Project Amendment Addendum

Hydrology and Hydraulic Modelling Report

Client: 892 Benalla-Yarrawonga Development Pty Ltd

10-Jun-2021

Revised Concept Plan

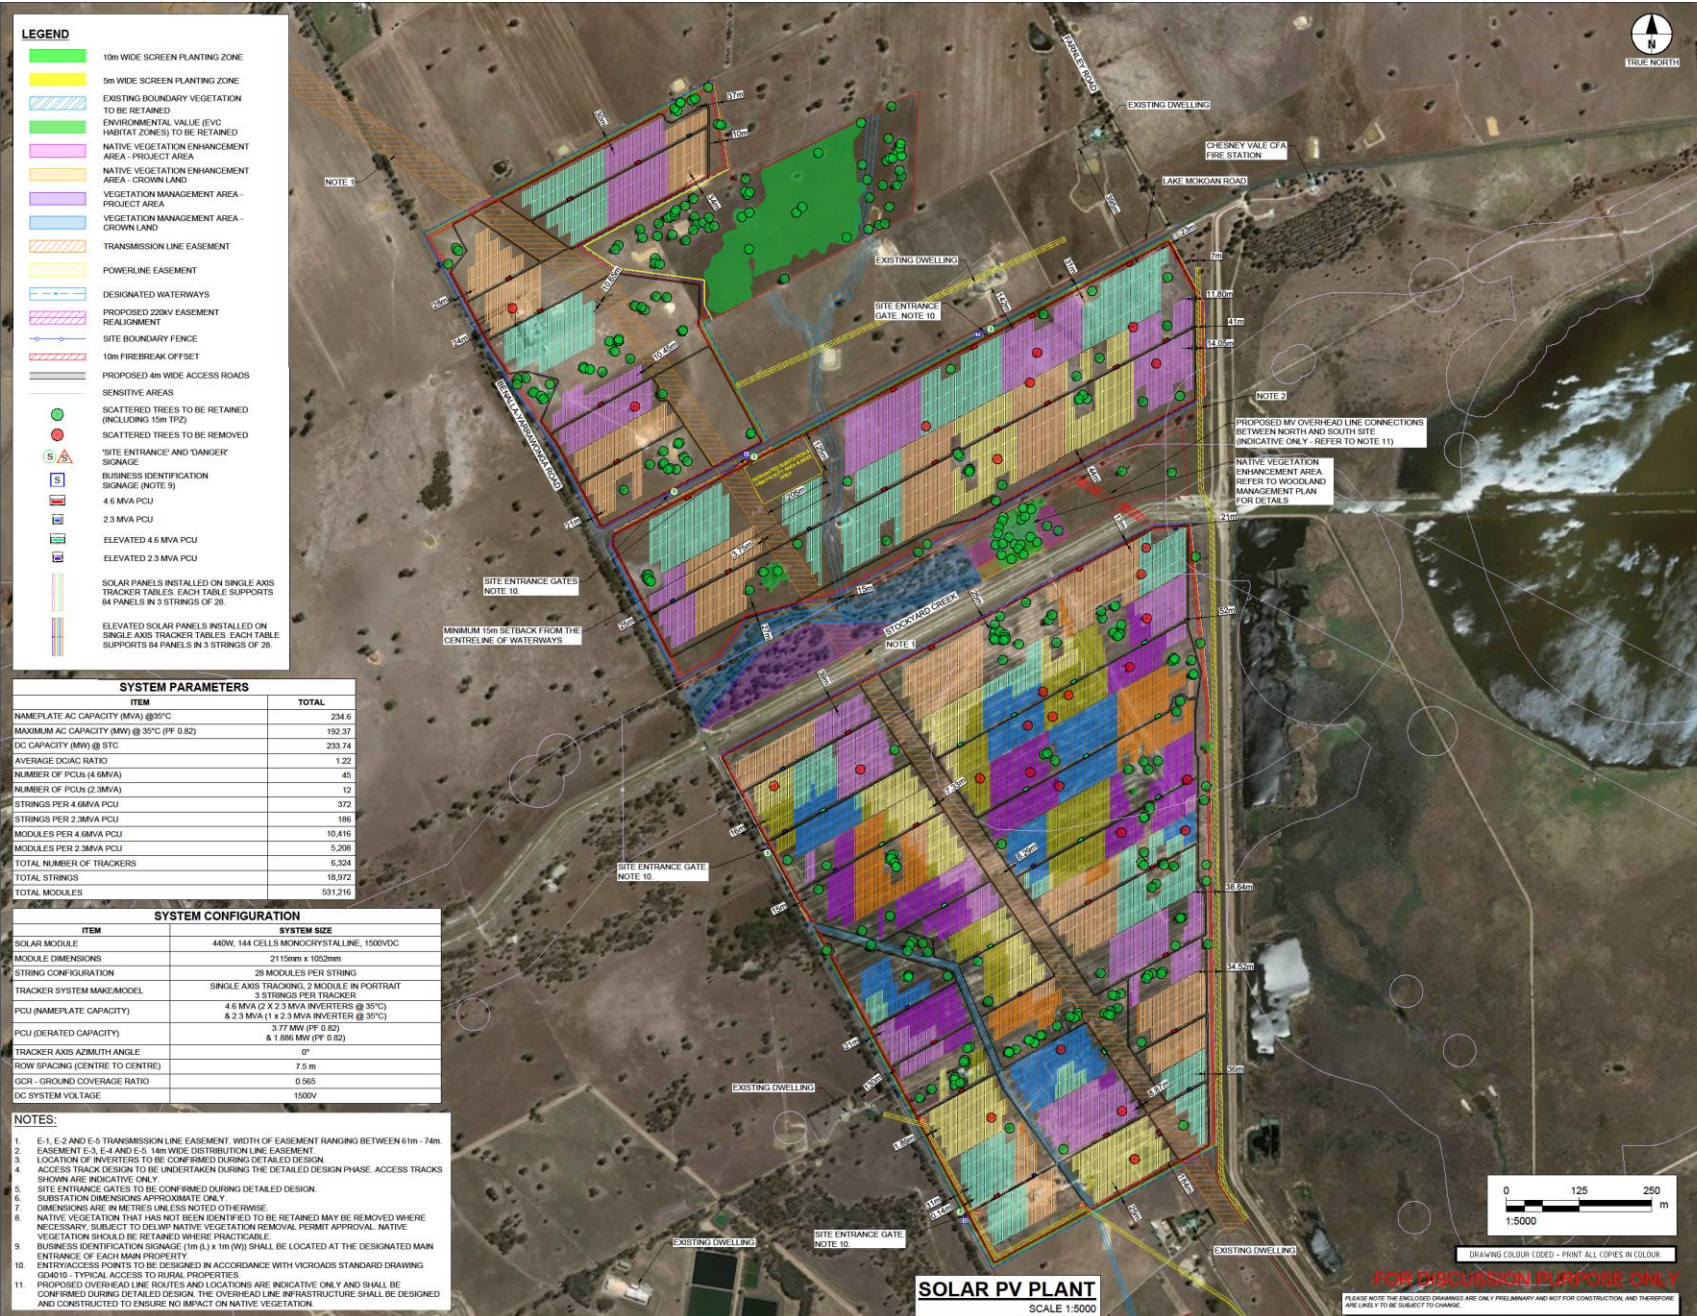
A review of the revised Concept Plan (60597809-DWG-EL-0003_Rev11 dated 3/6/2021), presented in Appendix A was undertaken to confirm any surface water impacts as a result of the changes to the project described above.

The results presented in the Hydrology and Hydraulic Modelling report (dated 27/08/20) (*The Report*) illustrate the revised substation location, on the south side of Lake Mokoan Road (Lot 1 TP173518), is largely outside the 1% AEP maximum flood extent. Furthermore, the proposed substation location is in an area with a maximum flood hazard categorisation of H1 (where H1 is deemed generally safe for people, vehicles and buildings).

The project area has been revised following the removal of land at 81 Lake Mokoan (Lot 2 PS625748) resulting in minor changes to the layout of solar energy facilities (Table 1). The revised layout presented in Appendix A and B does not encroach on the designated waterways or their agreed setbacks. The siting of solar energy facilities has also been designed in accordance with the requirements of the Goulburn Broken Catchment Management Authority.

The proposed amendments to the Project area and technical requirements in response to the RFI's raised by DELWP, dated 5 November 2020, and DELWP – Hume Region, on 26 November 2020, have been reviewed against the Hydrology and Hydraulic Assessment Report (dated 27/08/20).

Based on the planning amendments outlined herein, it is proposed the hydraulic modelling results and conclusions of *The Report* remain unchanged. It should also be noted that the assumptions, exclusions and limitations presented in Section 7 of *The Report* are applicable to the conclusions presented in this addendum.
